Access Compliance Report

Public Rights-of-Way

Intersection ID: 30277	Main Street: EMDEN_CT	Cross Street: RAVANNA_DR	Location: NE
ADA ID: DC722A1C0BC3	Ramp Type: BlendTrans1	Initial Pass/Fail: Pass	Overall Compliance: No
		Severity Score: 0.25

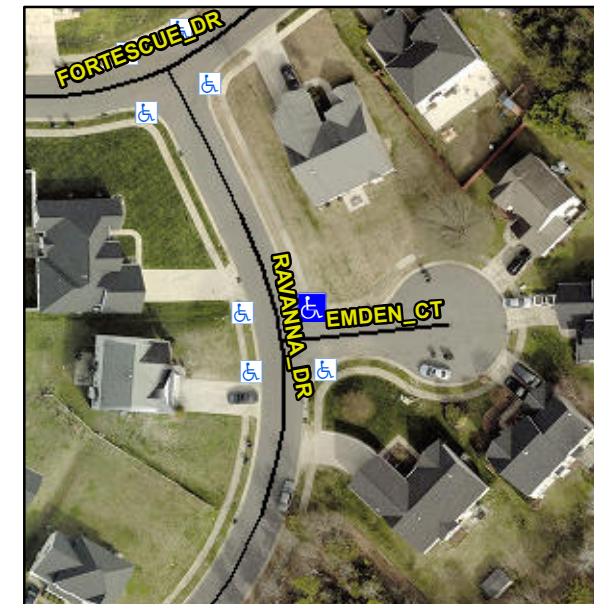
CURB WIDTH 31.0, ASP LIP PREVENTED GTR SLOPE

Not Found, R304.5.3, R304.2.1, R305.2, R304.5.4

Remove & Replace Curb Ramp With Two New Directional Ramps or Equivalent. Remove & Replace Gutter.
